Re: Reevaluation Report
Yellow Breeches Creek Re-Evaluation (S2-0250)
Permit No. E21-449
Upper Allen Township, Cumberland County

**HORIZONTAL DIRECTIONAL DRILL ANALYSIS
YELLOW BREECHES CREEK CROSSING
PADEP SECTION 105 PERMIT NO.S: E21-449
PA-CU-0203.0000-WX & PA-CU-0203.0000-WX-16
(SPLP HDD No. S2-0250)**

ORIGINAL AND REVISED HORIZONTAL DIRECTIONAL DRILL PLAN AND PROFILES

Figure 3. Original 16-Inch Plan and Profile

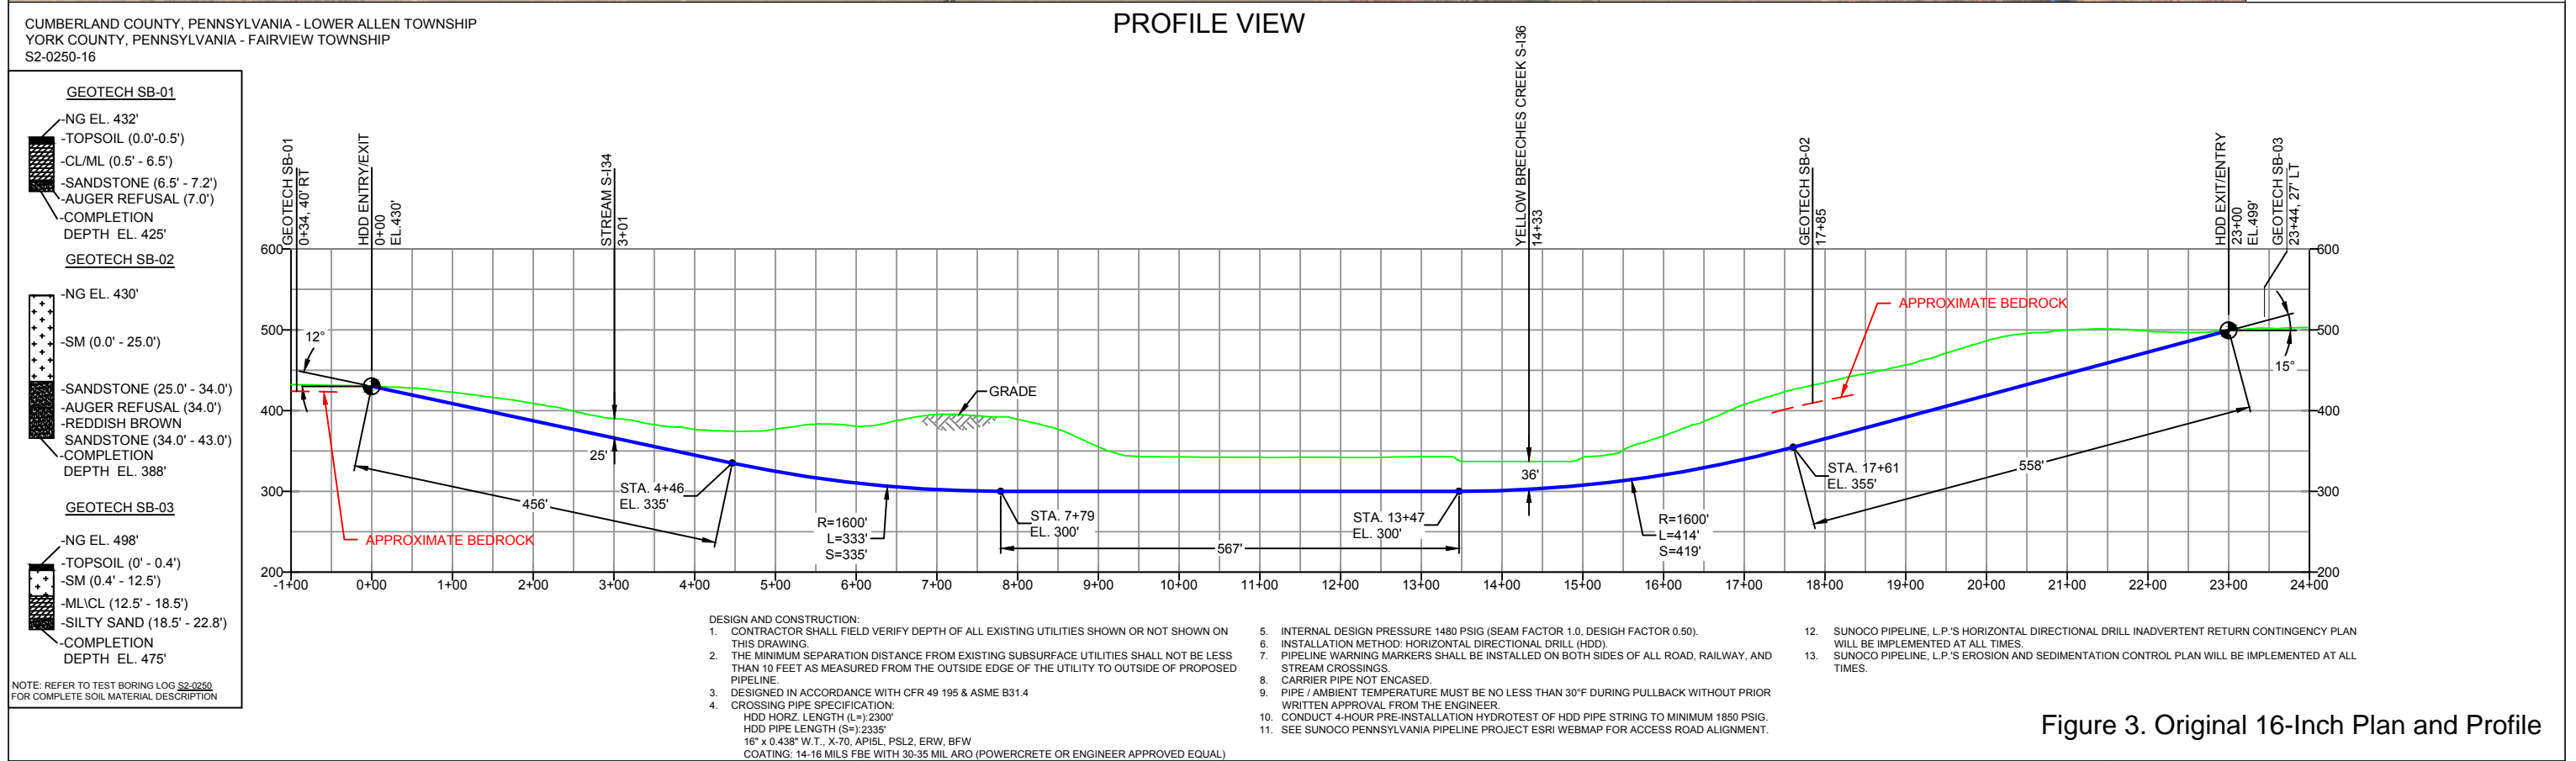
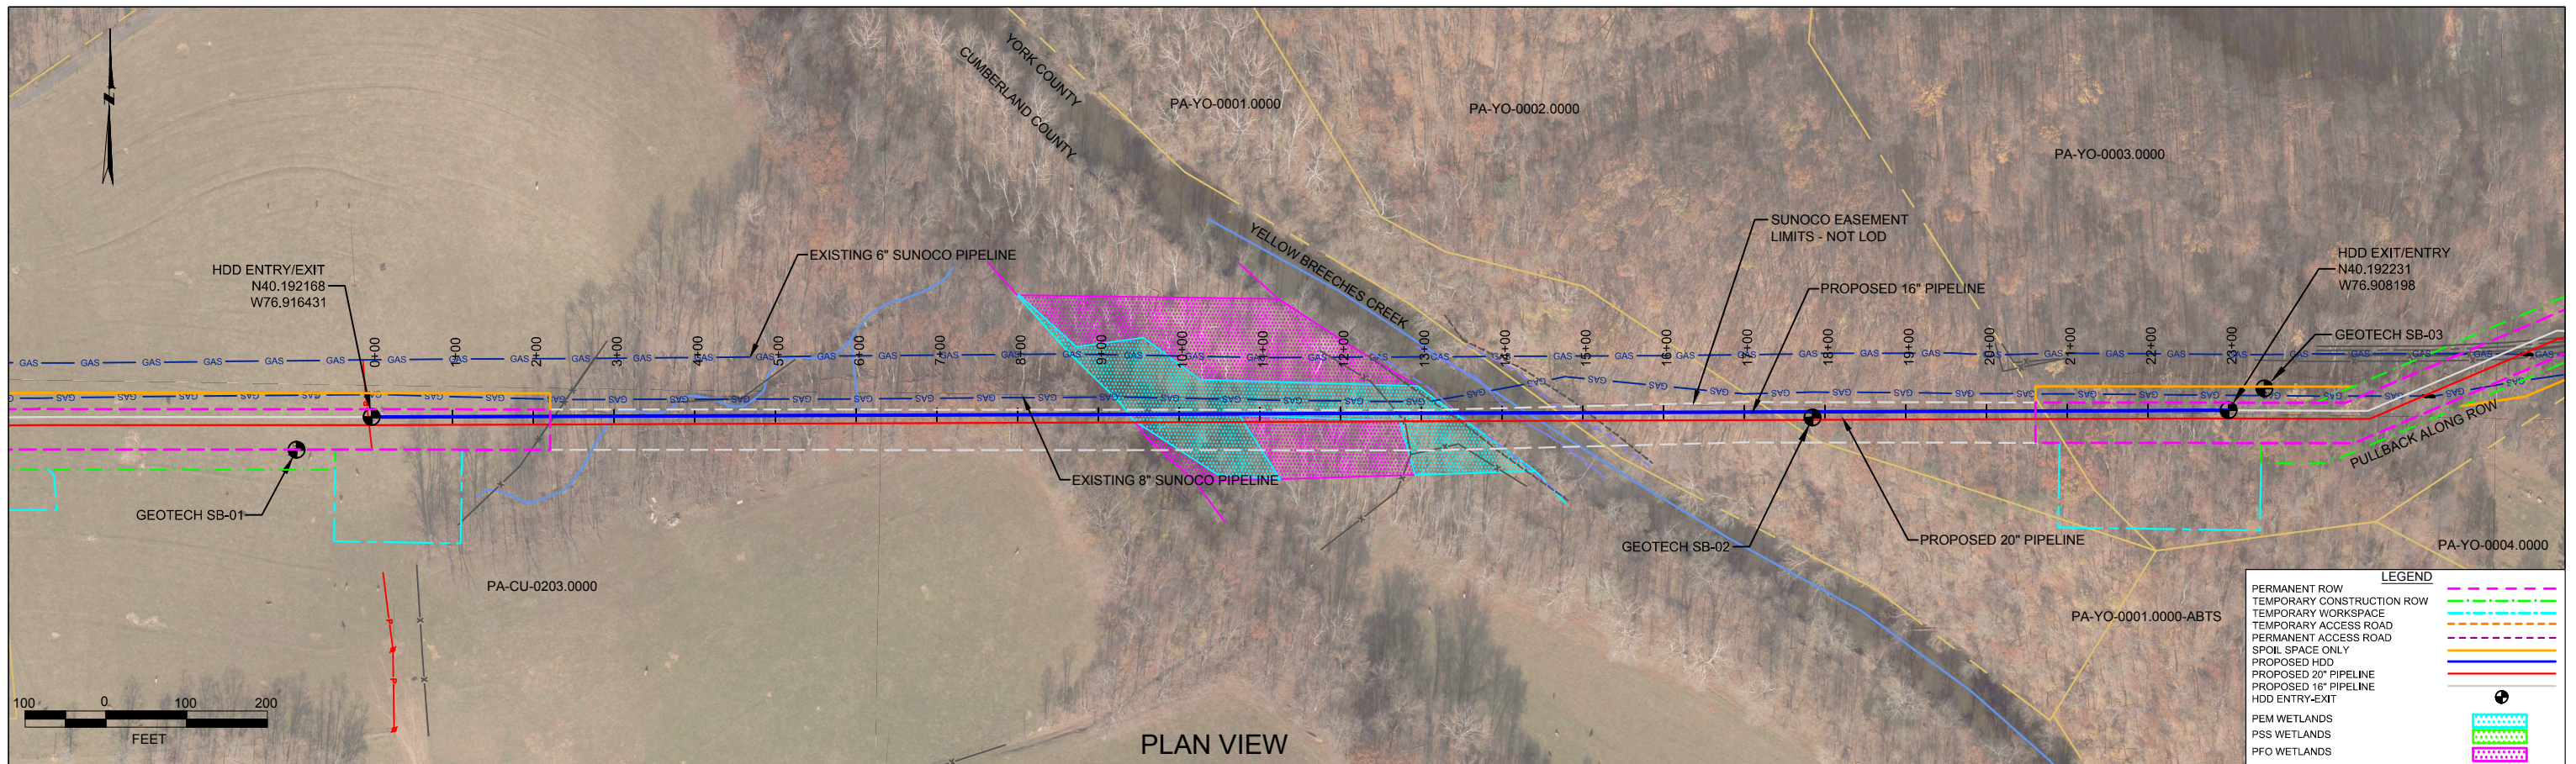
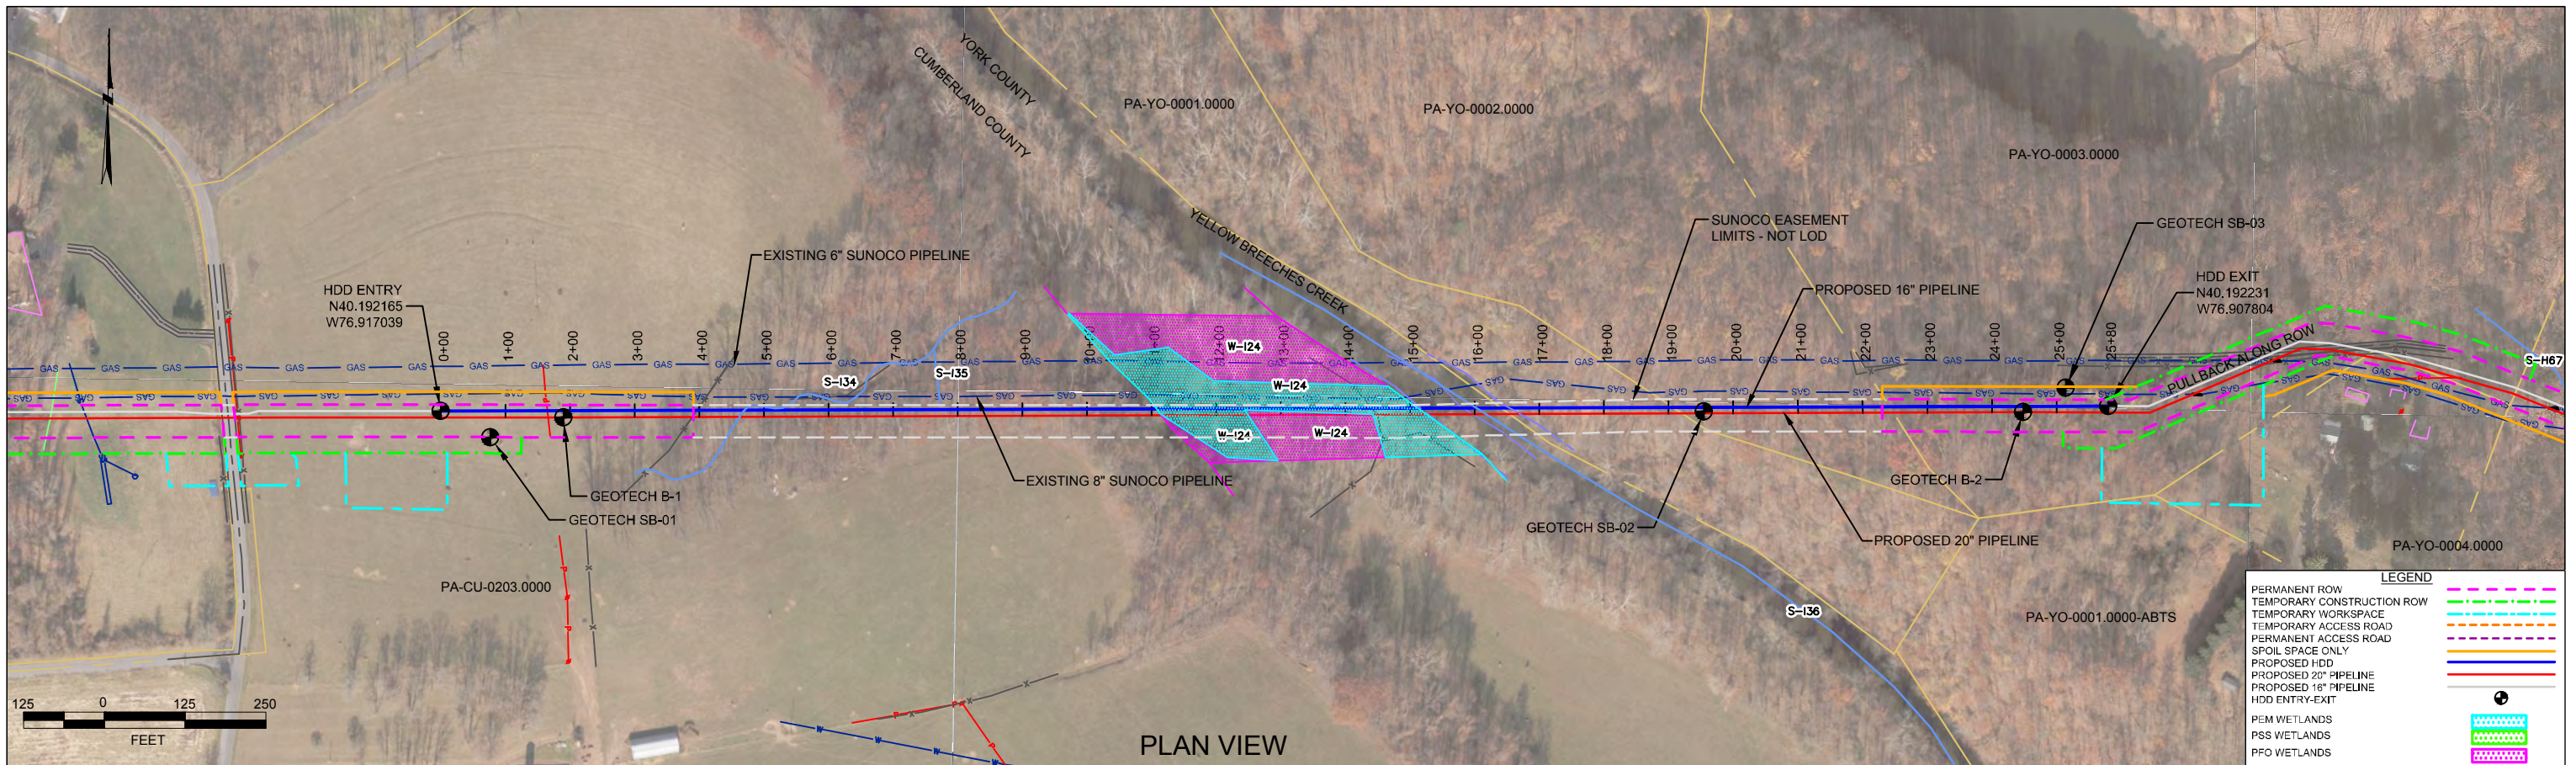
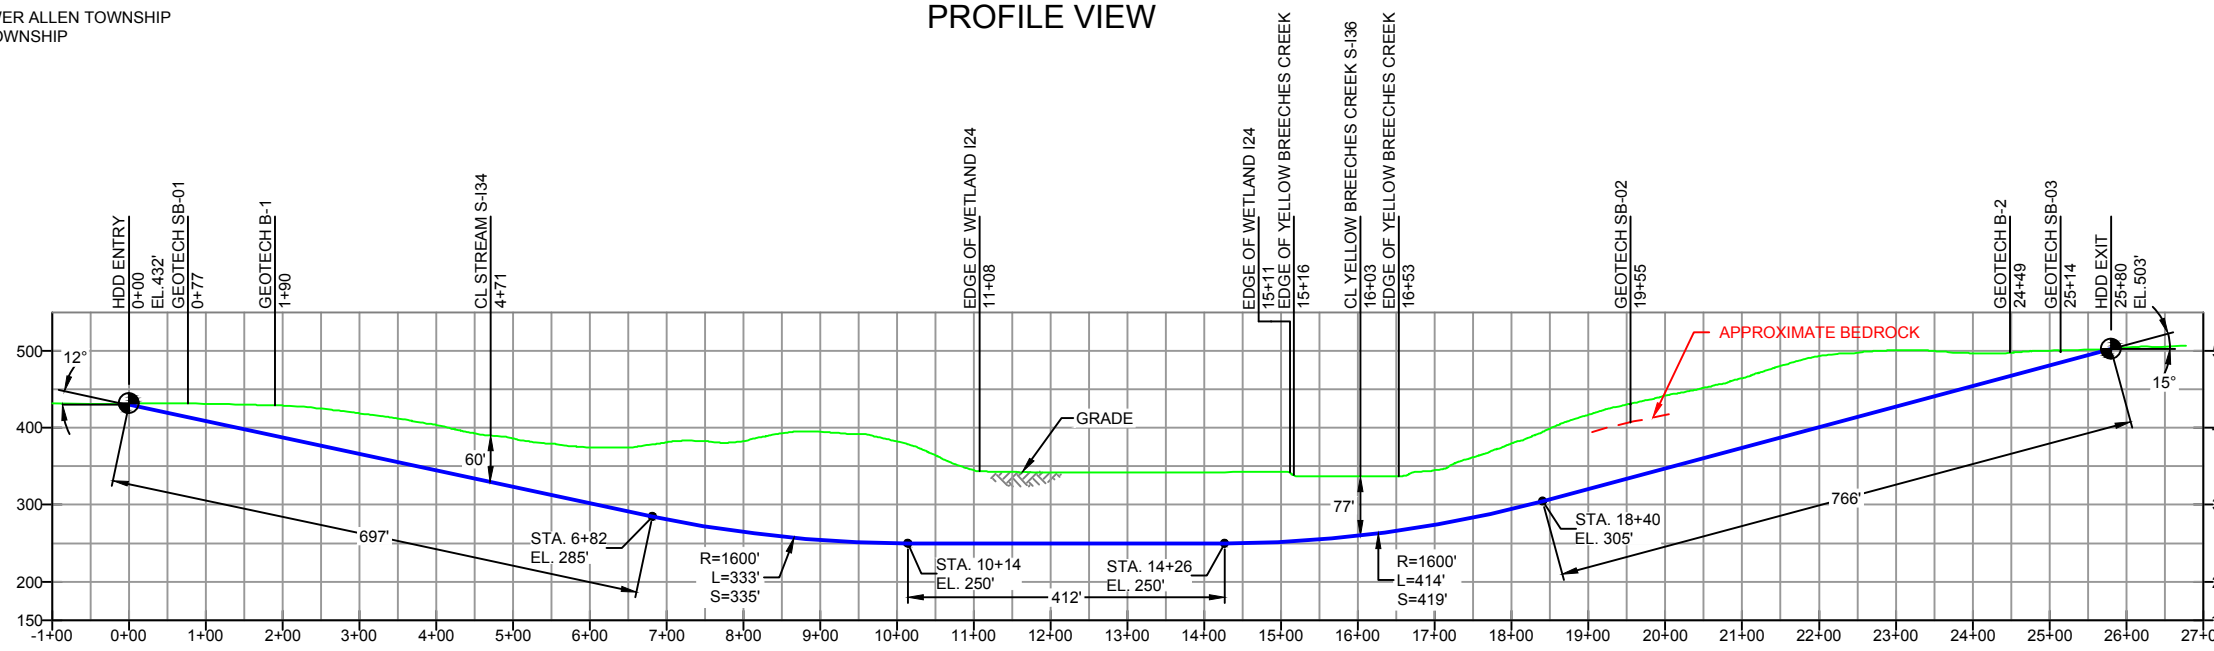
SPLP HDD consultants reviewed the HDD designs and geotechnical data for this area. Based upon this review, it was determined that the risk of IRs to waters overlying the HDD could be reduced by increasing the depth of the original permitted HDD profile. Additional geologic investigations have been completed and utilized in the redesign of the planned HDD. The redesign adjusts the HDD profile deeper to place the HDD pathway through bedrock having better structural integrity than a shallower profile and increase the overall length of the HDD due to pipe design requirements. A summary of the redesign factors is provided below.

It is SPLP's intent to modify the original profile design and to pursue a deeper and longer HDD profile. Figures 1 and 3 in Attachment 3 presents the original HDD plan and profiles. Figures 2 and 4 presents the revised HDD plan and profiles.
